June 14, 2024

NOTICE OF VIOLATION

INSPECTION REPORT

Item8GImg1: Overall pole.

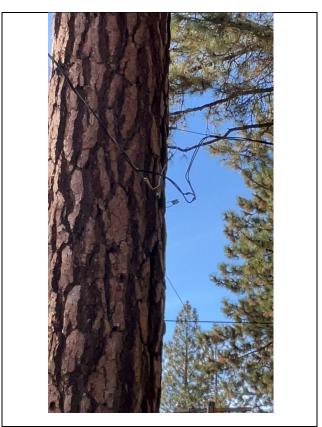
On pole ID 291897 at 8899 Salmon Ave, Kings Beach, CA, 96143, USA, 39.2361242144599, -120.016292223114, the inspector observed a tree attachment. The inspector's observation is documented in Violation 1 photographs, which are attachments to this report. Photo numbers Item8GImg1, Item8GImg2, and Item8GImg3 depict a tree attachment where the attachment was reported as removed.

- 1. Liberty Utilities' WMP 7.3.3.12 Other corrective action: Tree attachment work was identified as complete at this location.
- 2. Energy Safety understood Liberty Utilities' QDR submission to mean that all tree attachments would be removed from this location.
- 3. Liberty Utilities failed to remove the tree attachment and reroute the service line using a new pole.
